Well Name: RICK VAUGHN 7 WA FED COM	Well Location: T26S / R29E / SEC 7 / SWSW /	County or Parish/State:
Well Number: 9H	Type of Well: CONVENTIONAL GAS WELL	Allottee or Tribe Name:
Lease Number: NMNM138835	Unit or CA Name:	Unit or CA Number:
US Well Number: 3001548770	Well Status: Approved Application for Permit to Drill	Operator: MARATHON OIL PERMIAN LLC

Type of Submission: Notice of Intent

Procedure Description: Marathon Oil Respectfully Requests to make changes to the following sections of the Approved APD Drill Plan for the RICK VAUGHN 7 WA FED COM 9H well: Section 3 CASING - Surface: connection and safety factors - Intermediate: bottom set depth, weight, grade, connection, safety factors - Production: weight, connection, safety factors Section 4 CEMENT - Surface: Lead and Tail - Intermediate: Lead and Tail - Production: Tail, remove Lead Section 5 MUD - Surface: Bottom Depth - Intermediate: Top and Bottom Depth, Type, Min. Weight - Production: Top and bottom Depth

MARATHON OIL PERMIAN LLC
DRILLING AND OPERATIONS PLAN

Design Limits (5 1/2" Production Casing - Section 1)

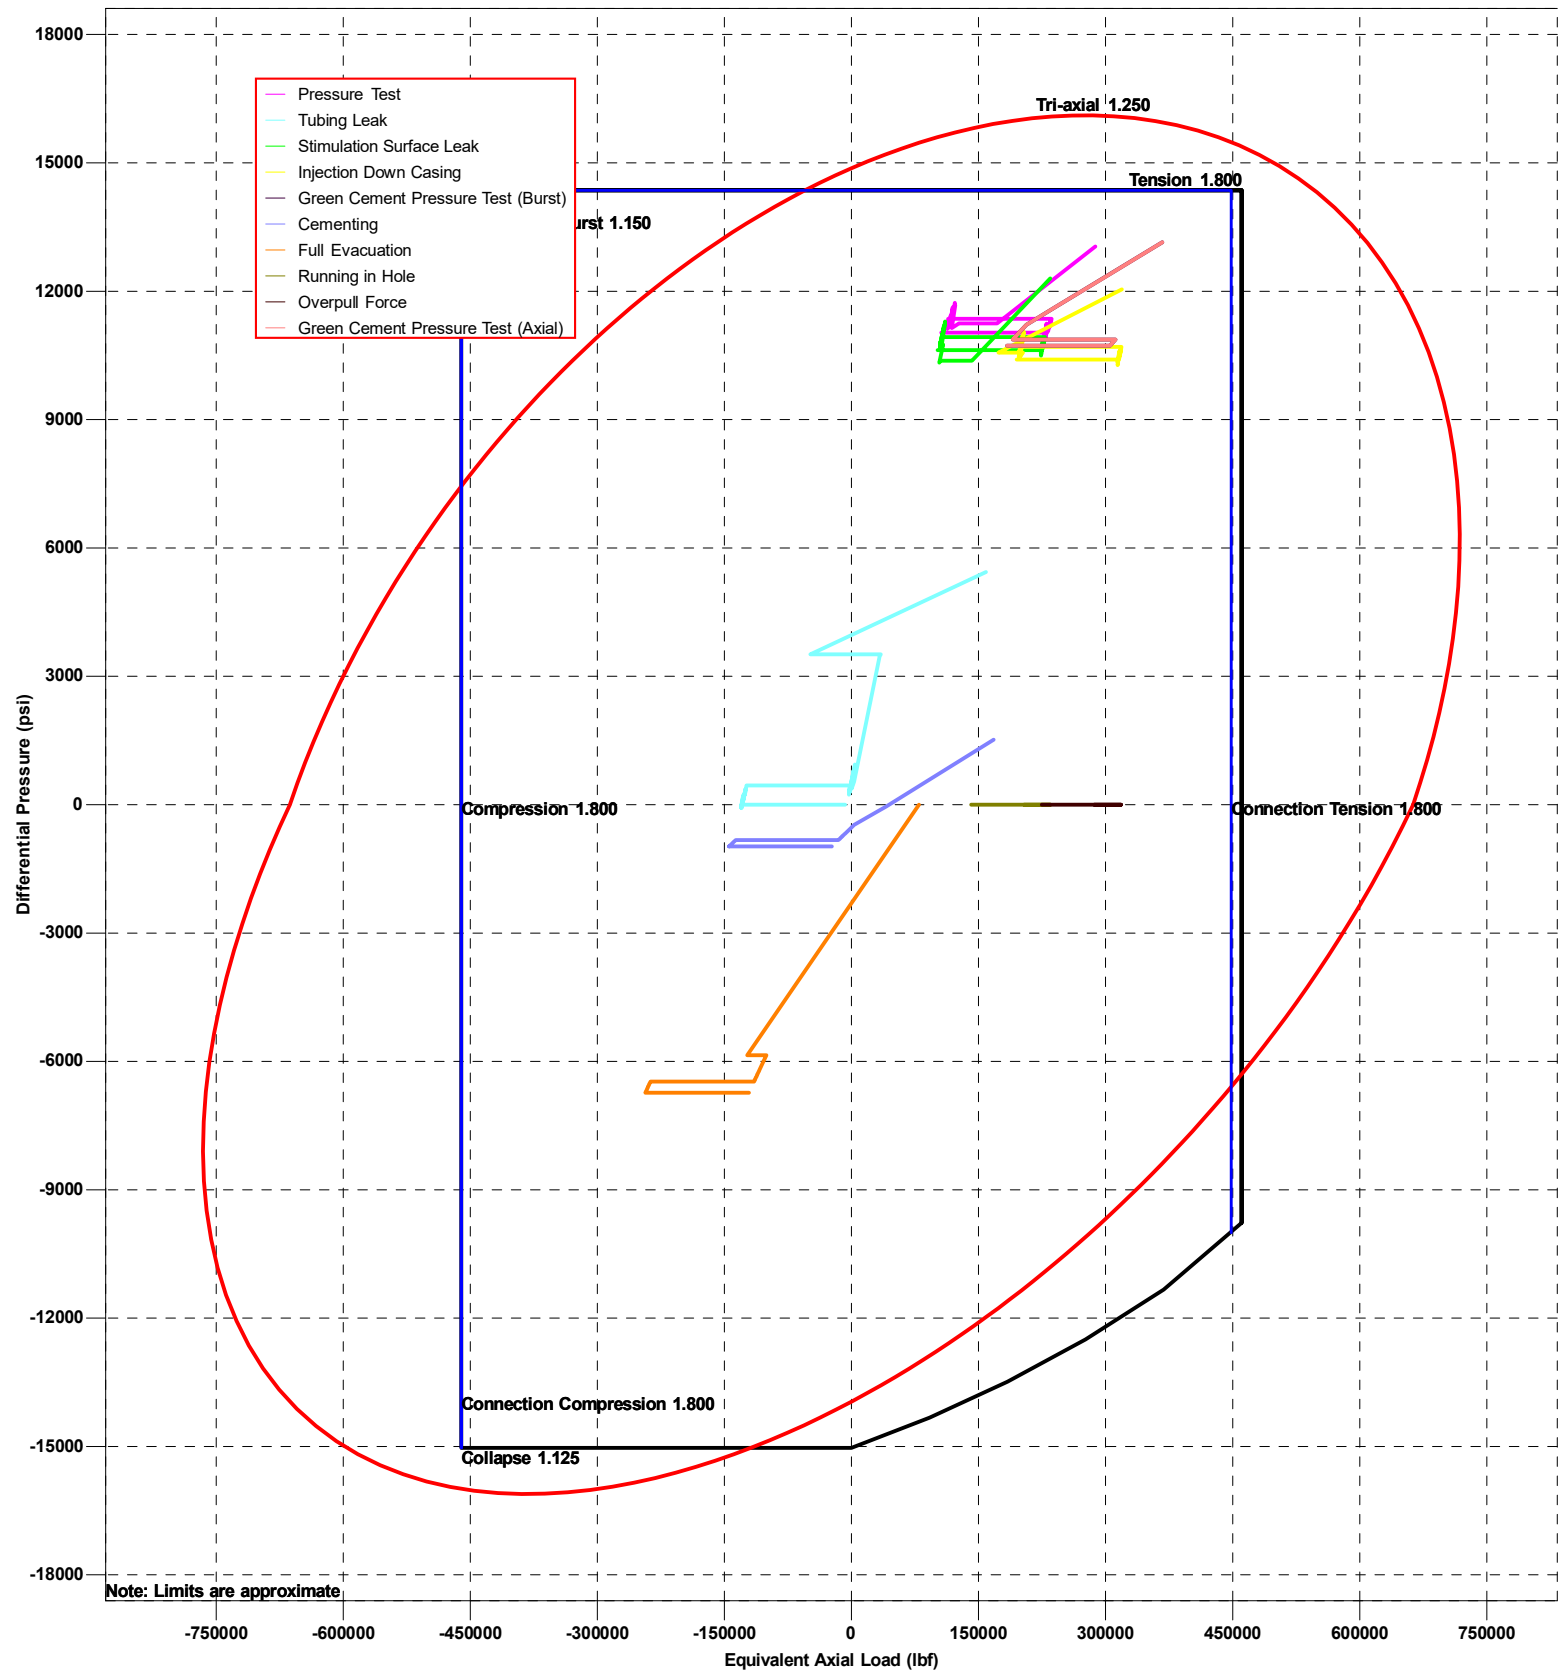
- Surface: connection and safety factors
- Intermediate: bottom set depth, weight, grade, connection, safety factors
- Production: weight, connection, safety factors

String Type	Hole Size	Csg Size	Top Set MD	Bottom Set MD	Top Set TVD	Bottom Set TVD	Top Set MSL	Bottom Set MSL	Weight (lbs/ft)	Grade	Conn.	SF Collapse	SF Burst	SF Tension
Surface	17 1/2	13 3/8	0	689	0	689	2910	2222	54.5	J55	BTC	5.22	1.81	4.52
Intermediate	12 1/4	9 5/8	0	9214	0	9187	2910	-6276	40	P110	BTC	1.20	1.42	2.44
Production	8 3/4	5 1/2	0	19875	0	9725	2910	-6814	23	P110	TLW	2.53	1.26	2.22
